DeYOUNG SUBDIVISION Construction Drawings El Paso County, Colorado

NO.	REVISION	DATE
A	EPC SUBMITTAL	4/22/20
B	EPC COMMENTS	9/09/20

PCD PROJECT NO. MS-20-001

SHEET: C1.1

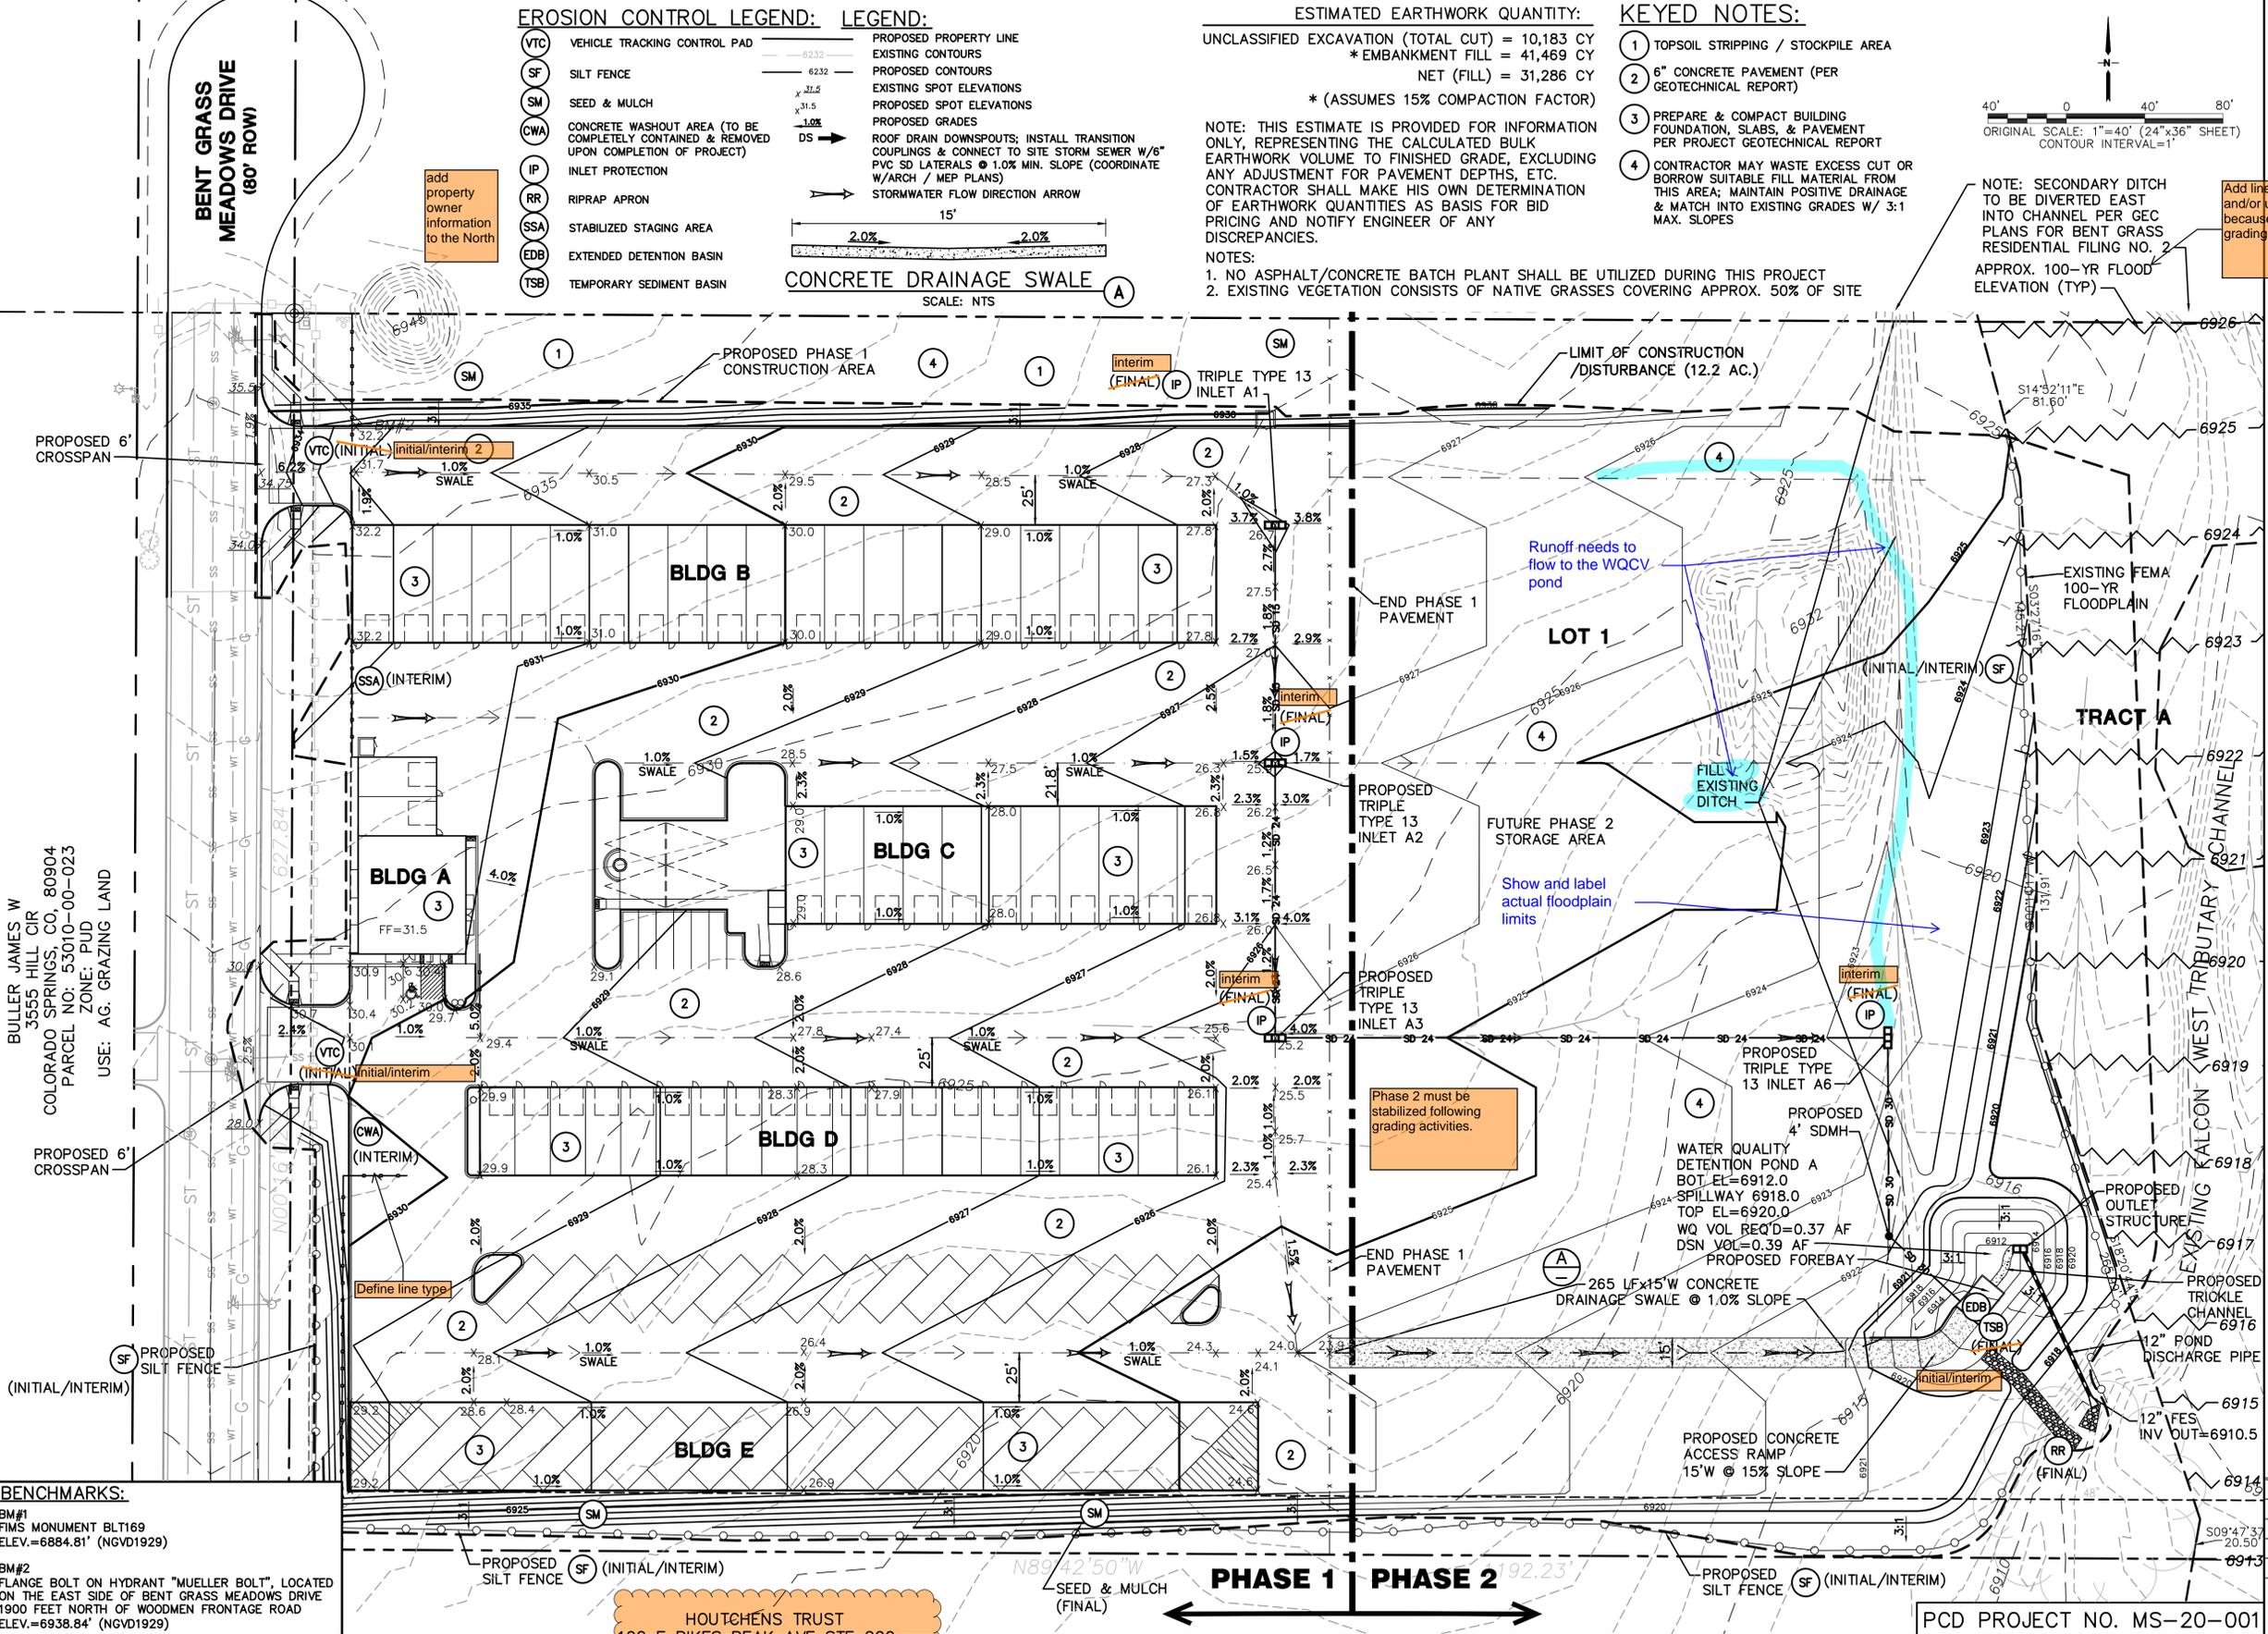
show areas of cut/fill

Add line type to legend and/or use gray type because its not a grading contour

adjust text

SHEET: C3.1

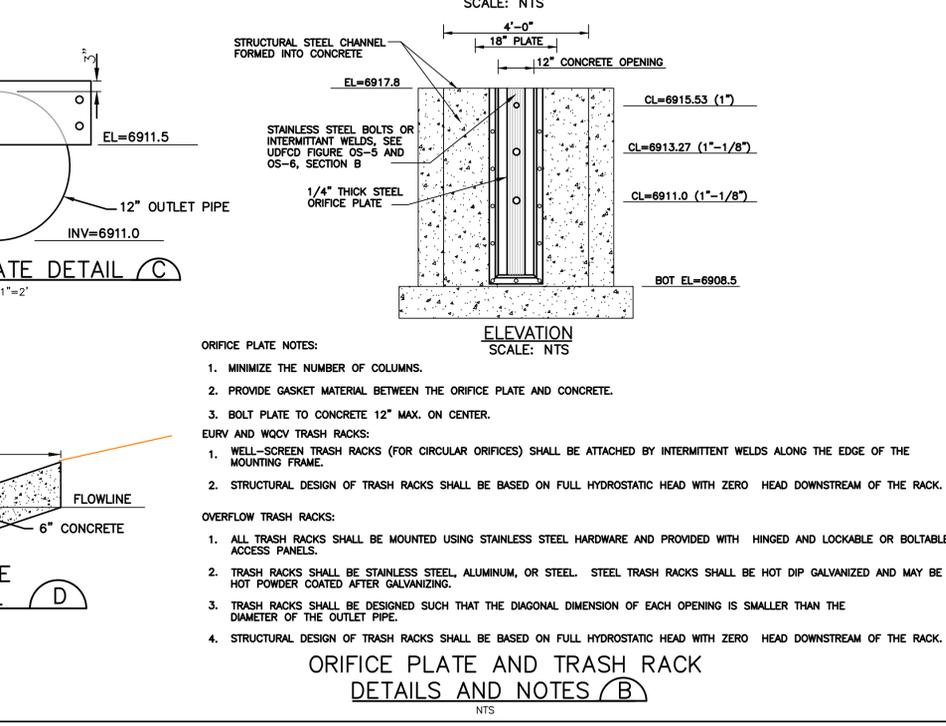
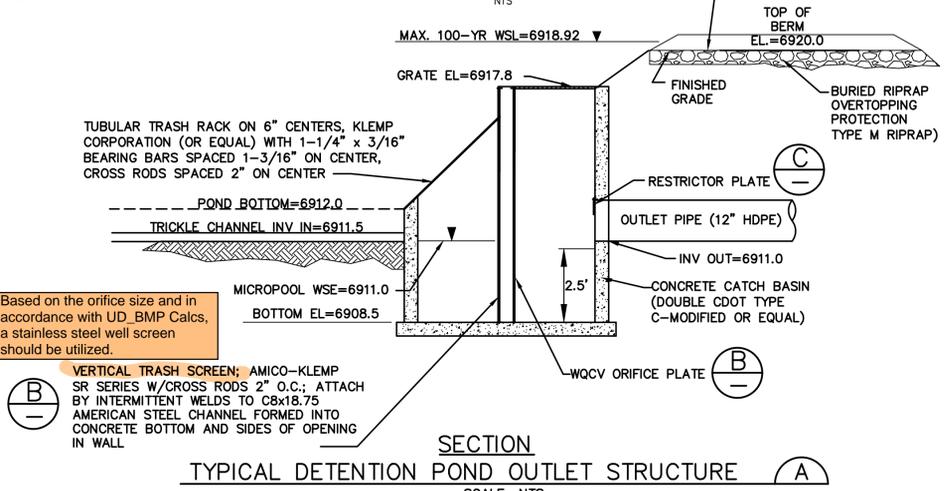
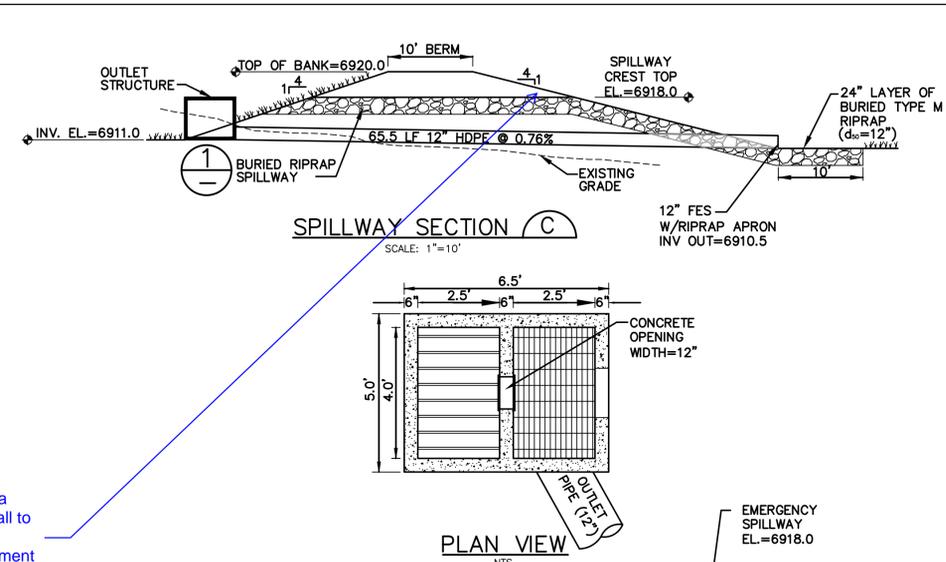
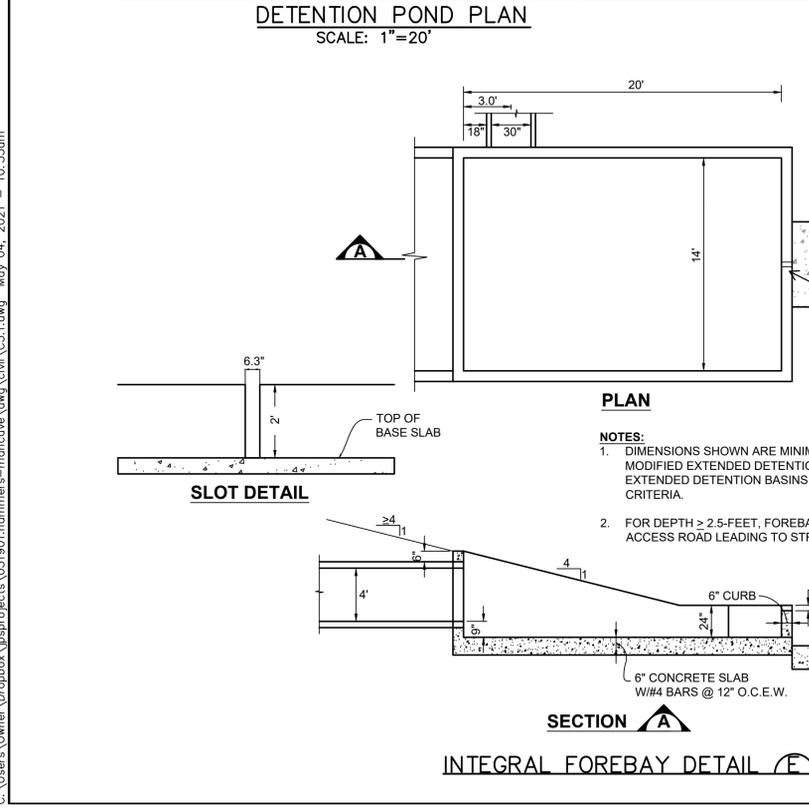
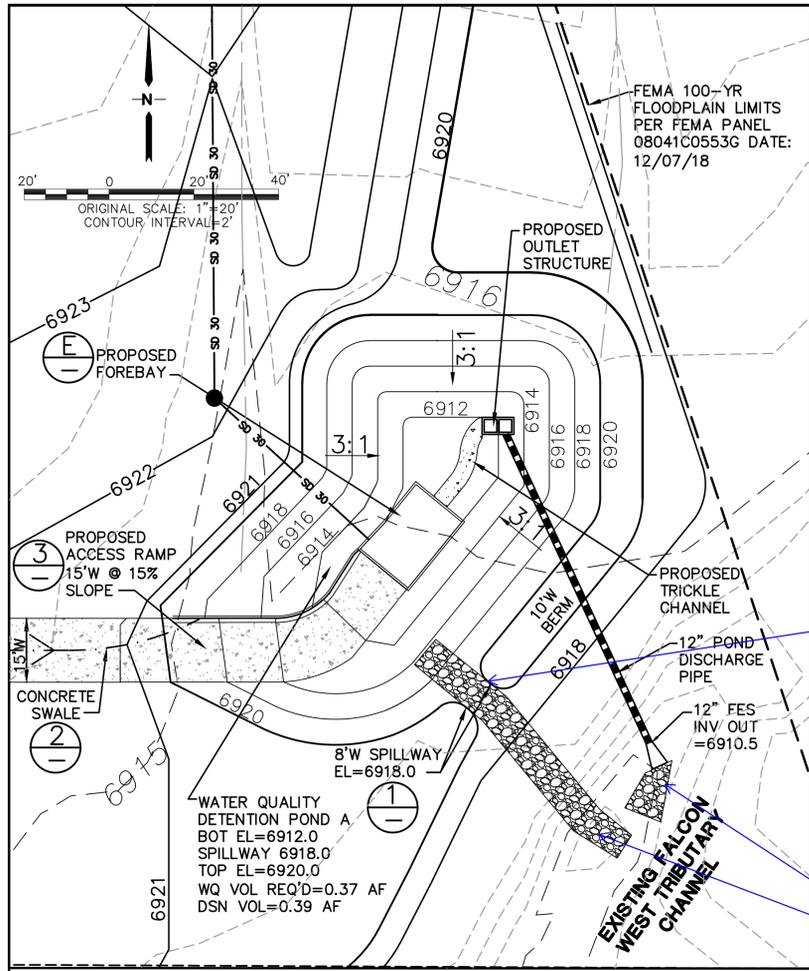
provide a cutoff wall to prevent embankment failure

This will be regularly overtopping; additional detailing of the spillway and channel protection is required. A check structure may be required in the channel to prevent headcutting upstream from the new point discharge location. Coordination will be required with the Bent Grass developer providing the channel design.

Specify installation instructions and mix ratio for soil riprap. As an example, note: "Per MHFD Spec Section 31-37-00, the soil material shall be native or topsoil and mixed with 65% riprap and 35% soil by volume. And soil riprap shall consist of uniform mixture of soil and riprap without voids." And specify the riprap designation per Table 1 of the same spec.

To avoid contractor confusion during install, include entire spillway width measurements

Pond bottom should have a minimum slope of 3% to the trickle channel

call out notch width
